UNITED STATES PATENT AND TRADEMARK OFFICE

APPLICATION NO.	FILING DATE	FIRST NAMED INVENTOR	ATTORNEY DOCKET NO.	CONFIRMATION NO.
10/554,114	09/28/2006	Michael A. Hoopes	18801-00733	9365
7590 08/01/2008				
Robert H Earp III McDonald Hopkins Company 2100 Bank One Center 600 Superior Avenue East Cleveland, OH 44114-2653				
EXAMINER				
WINNER, TONY H				
ART UNIT		PAPER NUMBER		
3611				
MAIL DATE		DELIVERY MODE		
08/01/2008		PAPER

Office Action Summary

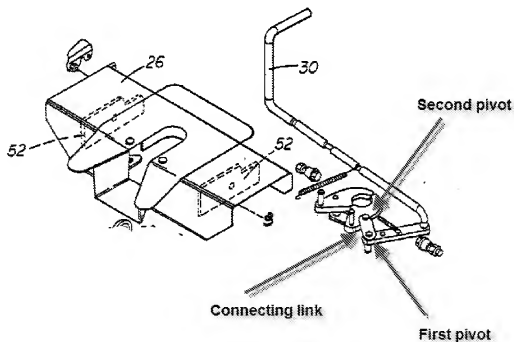
McCoy discloses a fifth wheel hitch assembly, the structure comprising:

- a. a base assembly (12);
- b. a head assembly (26) connected to said base assembly, said head assembly

having a slot (cut away portion of element 52 of figure 2); and

c. a jaw assembly (28) connected to said head assembly, said jaw assembly comprising:

- i. a jaw body having a bearing surface for engaging a king pin of a trailer;
- ii. a control handle (30) having a notch that is engageable with said head assembly by shifting said control handle transversely in said slot; and
- iii. a connecting link (figure 2) , said connecting link being pivotally connected to said control handle by a first pivot pin and to said jaw body by a second pivot pin.

McCoy lacks stepped bearing surface with regard to the jaw body.
